UNITED STATES PATENT AND TRADEMARK OFFICE

Office Action Summary

10/527,408

DETAILED ACTION

FIG. 3

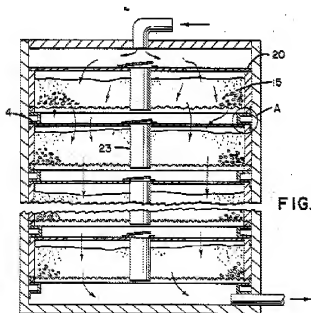
8. Claims 1-6 are rejected under 35 U.S.C. 102(b) as being anticipated by Barbaro (U.S. 4,906,381). Barbaro teaches a water treatment apparatus having an inlet port 11 and an outlet

port 12 and a plurality of removable container modules 15 including sand therein (col. 1, line 60; col. 2, lines 35-51) [as in claim 1-5]. As shown by the arrows, flow through the modules is serial.

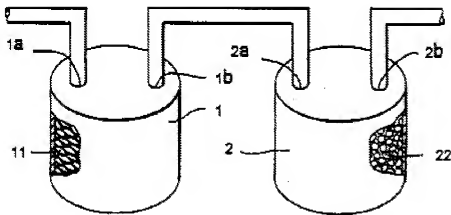
10. Claims 1-6 are rejected under 35 U.S.C. 102(b) as being clearly anticipated by EP 0381032, hereinafter '032.

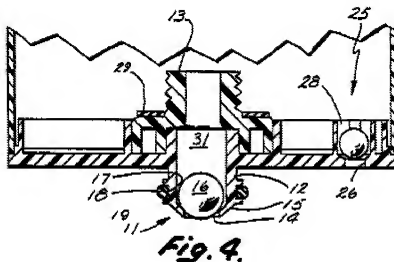
Holland in view of Gershon doesn't teach the filtering elements to be individually removable and having respective inlet and outlet ports as well as sealing elements. However such is taught by Kool. The inlet and outlet ports and sealing elements are shown below [as in claims 7-8].

It is considered that it would have been obvious to one ordinarily skilled in the art at the time of the invention to have the removability and sealing inlet and outlet of Kool for each container of

the modified Holland, since Kool teaches the benefit of preventing water leakage during filter replacement (col. 1, lines 15-19).
